Technical Service Bulletin: tsb100608

New Flat Cooling Plate Pistons

This Technical Service Bulletin supersedes topic 06T1-23. Replace topic 06T1-23 with this topic.

Figure 2, Flat Plate Segments

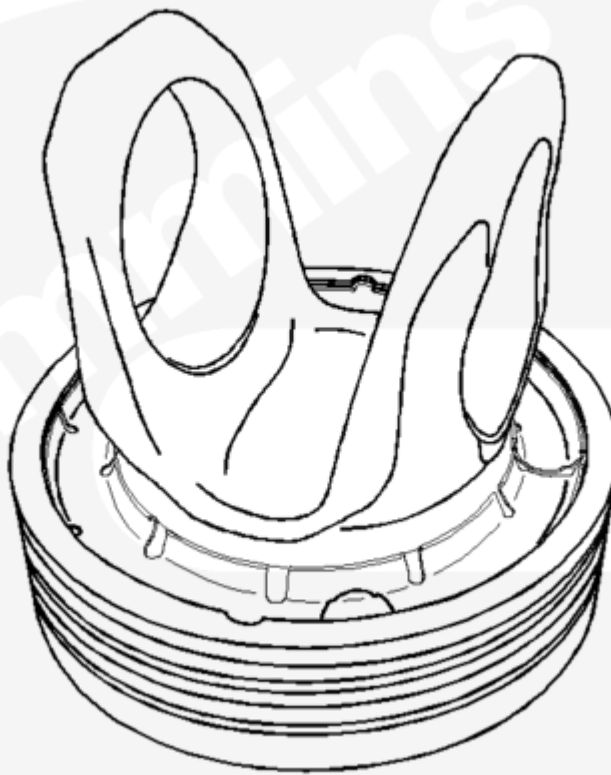
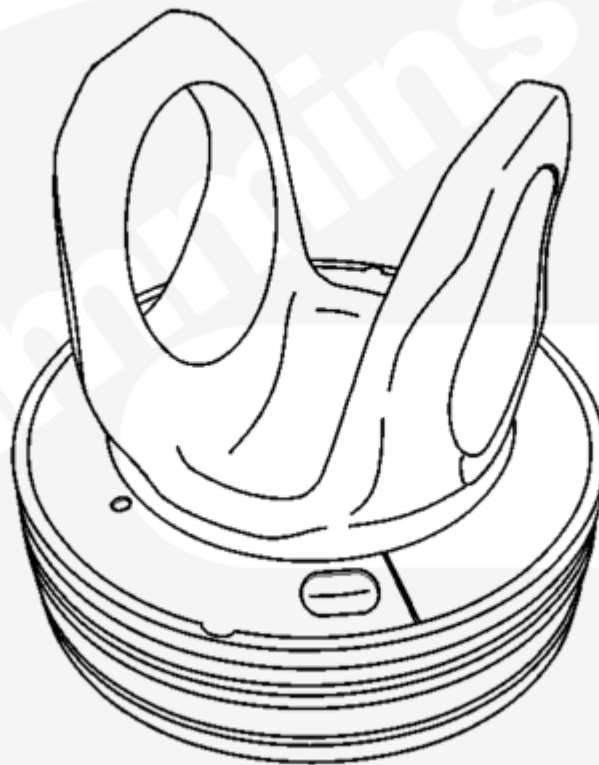
The underside of the articulated piston crown has two domed plates that form the piston cooling gallery. The oil that flows through this gallery removes heat from the piston crown. The domed plates are **not** serviceable. Refer to Figure 1 to see this design.

Three new flat cooling plate pistons have been released. The underside of the crown has been redesigned with two nonserviceable flat cooling plate segments. Refer to Figure 2 to see this design.

When an M11 industrial engine (CPL 2119, 2336, 2363, 2503, 2916, 2917, 2918, 2828, and 2829) is repaired or rebuilt with the new flat cooling plate pistons, the engine dataplate **must** be stamped with FFNR-8.

When an M11 Plus automotive engine (CPL 2036, 2037, 2370, and 2371) is repaired or rebuilt with the new flat cooling plate piston, the engine dataplate **must** be stamped with FF255. Targeted applications include refuse/disposal trucks, mixers, food delivery, dump trucks, and bulk haulers.

When an ISM automotive engine (CPL 2607 and 2608) is repaired or rebuilt with a new flat cooling plate piston, the engine dataplate **must** be stamped with FF337. Targeted applications include refuse/disposal trucks, highway department/DOT dump trucks, and mixers.

| New Piston Kits                                                                                                                     |            |                            |
|-------------------------------------------------------------------------------------------------------------------------------------|------------|----------------------------|
| NOTE: Repairs and rebuilds with the new pistons/kits <b>must</b> be done in complete engine sets, due to piston weight differences. |            |                            |
